16th August 2019

Reference: 190226.02FA

LETTER OF RESPONSE TO KING AND CAMPBELL COMMENTS FOR PROPOSED LEISURE & ENTERTAINMENT PRECINCT AT WARLTERS STREET & PARK STREET, PORT MACQUARIE

Atelier Architects DA11 Rev A markup detailing concrete pavement extent.

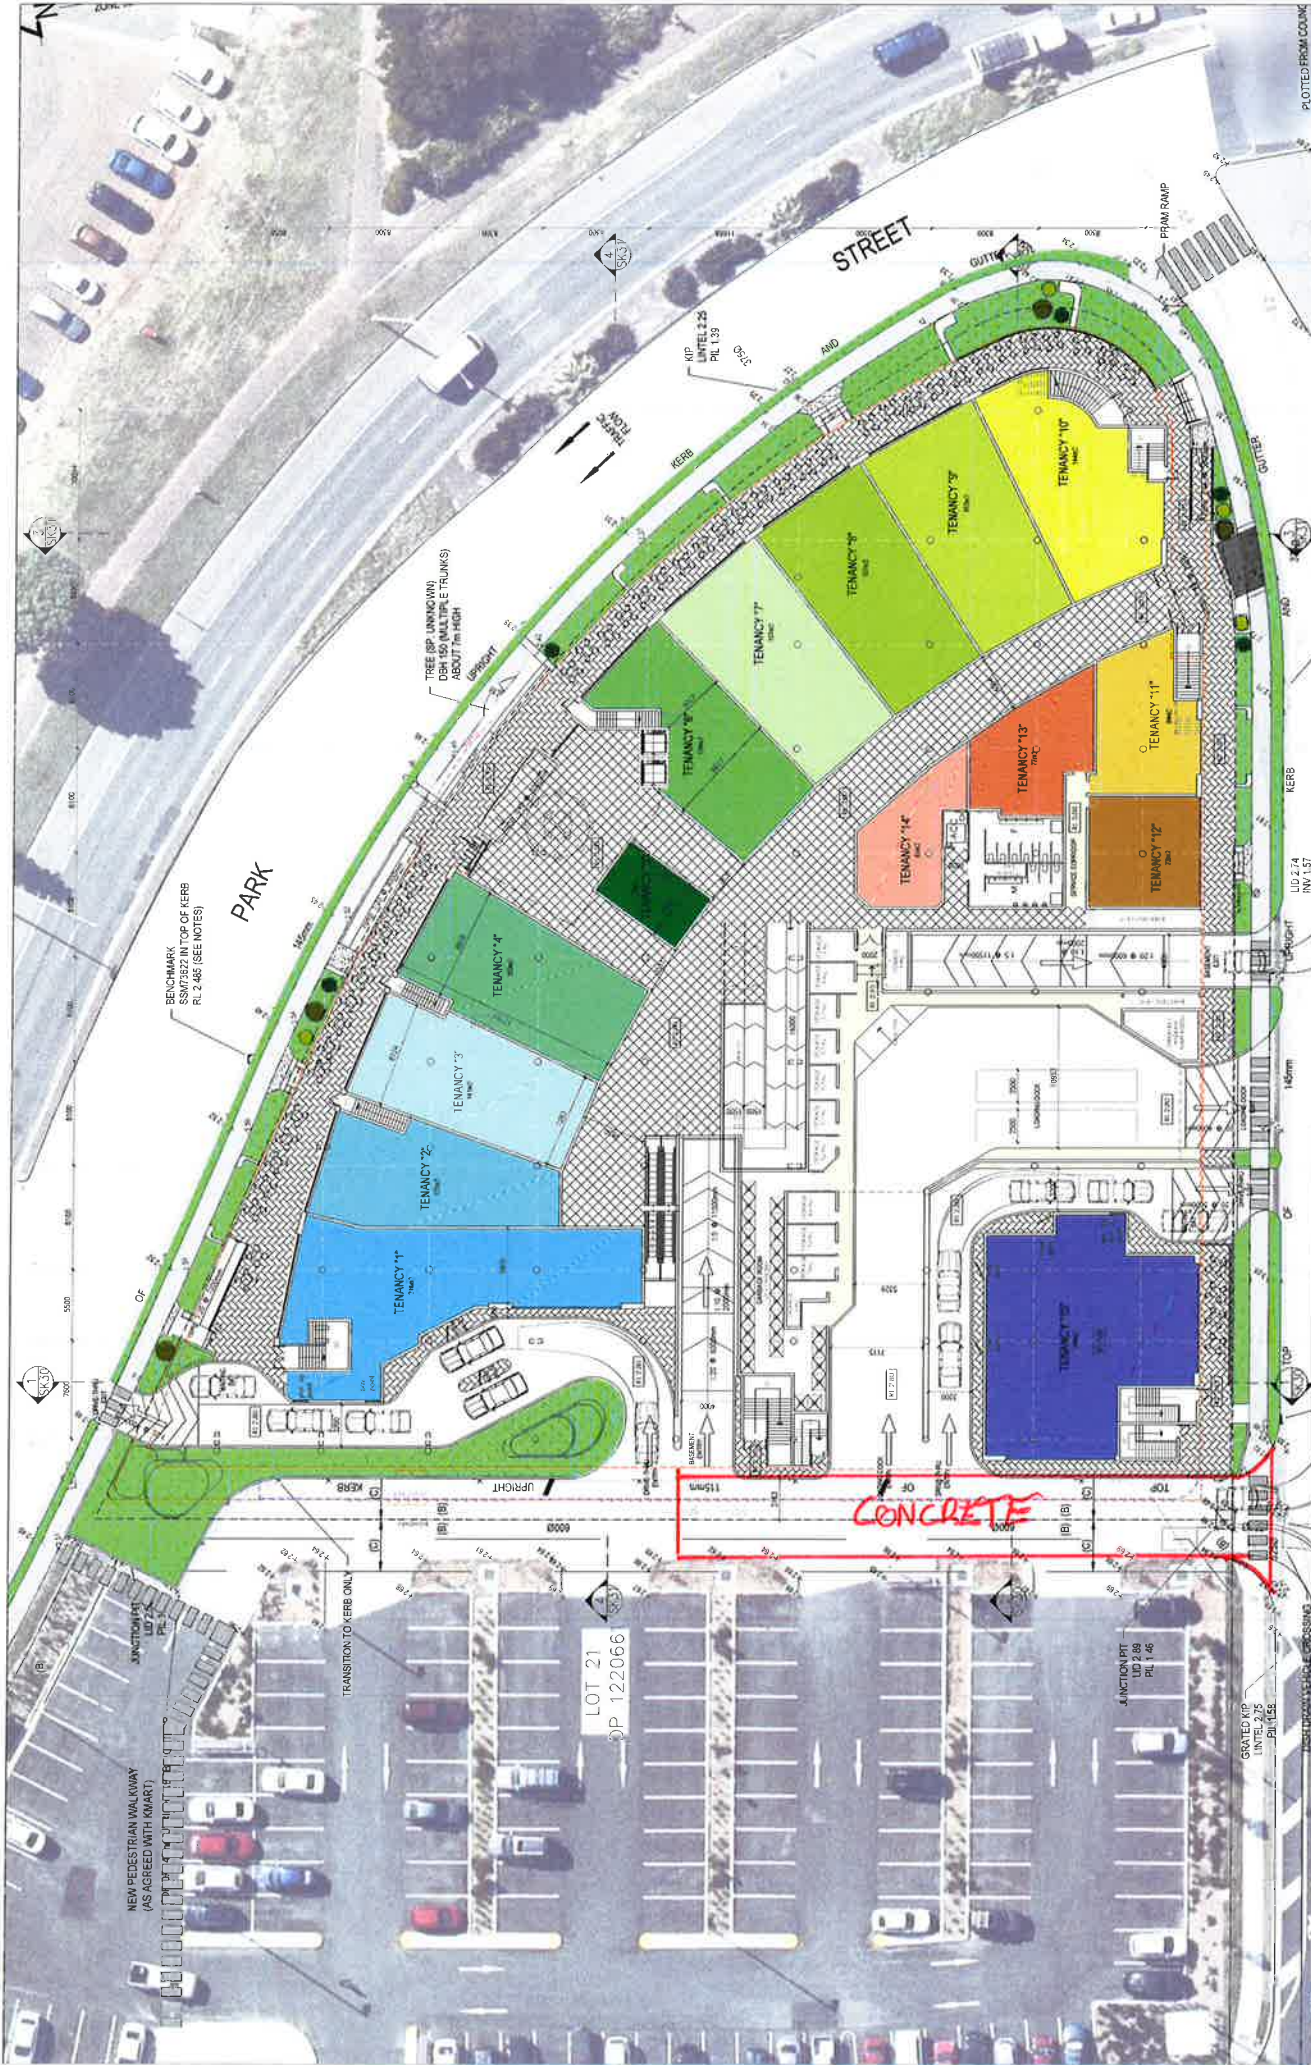
- Proposed development to incorporate pedestrian connectivity and K-Mart signage as agreed between K-Mart and Planet Warriewood in accordance with attached K-Mart letter dated 21st December 2018.
- Proposed development to restrict loading dock use outside the hours of 10am-5pm and limit HRV size to 12.5m length.
- Carpark use as agreed between K-Mart and Planet Warriewood.
- Proposed development to replace existing asphalt pavement from Warlters Rd upto and including the loading dock entry as a minimum with suitable concrete pavement at no cost to MPG (refer attached mark up for extent).
